Access Compliance Report

Public Rights-of-Way

(Curb Ramps)

Intersection ID: 16947	Main Street: CRAIG_AV	Cross Street: DELANE_AV	Location:	N
ADA ID: 38593062E0F3	Ramp Type: PerpDiag	Initial Pass/Fail: Fail	Overall Compliance: No	Severity Score: 25
Codes/Mitigation Info/Possible Solution		Field Measurements/Component Compliance

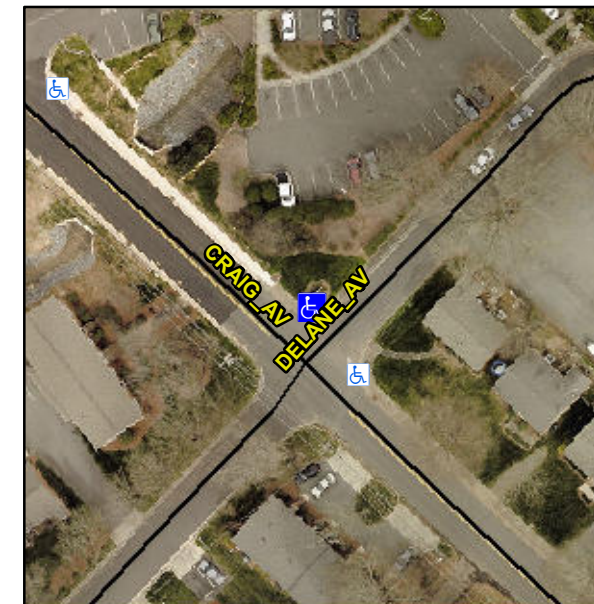
Not Found, R304.2.2, R304.5.3

Compliance	Description	Data	Compliance	Description	Data
N/A	Ramp Length (in)	49.0	No	Ramp Slope (%)	9.6
Yes	Ramp Width (in)	48.0	No	Ramp XSlope (%)	5.6
N/A	Flare Type LT	N/A	N/A	Flare Type RT	N/A
N/A	Flare Slope LT (%)	N/A	N/A	Flare Slope RT (%)	N/A
N/A	Flare Traversable LT?	N/A	N/A	Flare Traversable RT?	N/A
N/A	Landing Length (in)	N/A	N/A	DWS Provided?	N/A
N/A	Landing Width (in)	N/A	N/A	DWS Contrast?	N/A
N/A	Landing Slope (%)	N/A	N/A	DWS Length (in)	N/A
N/A	Landing X Slope (%)	N/A	N/A	DWS Full Width?	N/A
N/A	Landing Curb? (Y/N)	N/A	N/A	DWS Offset (in)	N/A
N/A	Shared Landing?	N/A			
N/A	Gutter Ponding?	N/A	N/A	Gutter Slope (%)	N/A
N/A	Gutter Lip Ht (in)	N/A	N/A	Gutter X Slope (%)	N/A
N/A	Painted X Walk1?	No	N/A	Painted X Walk2?	No
	X Walk 1 Direction	To SE		X Walk 2 Direction	To SW
N/A	X Walk 1 Width (in)	N/A	N/A	X Walk 2 Width (in)	N/A
	X Walk 1 Slope (%)	0.3		X Walk 2 Slope (%)	7.2
	X Walk 1 X Slope (%)	6.9		X Walk 2 X Slope (%)	1.0

Remove & Replace Curb Ramp With Two New Directional Ramps or Equivalent.
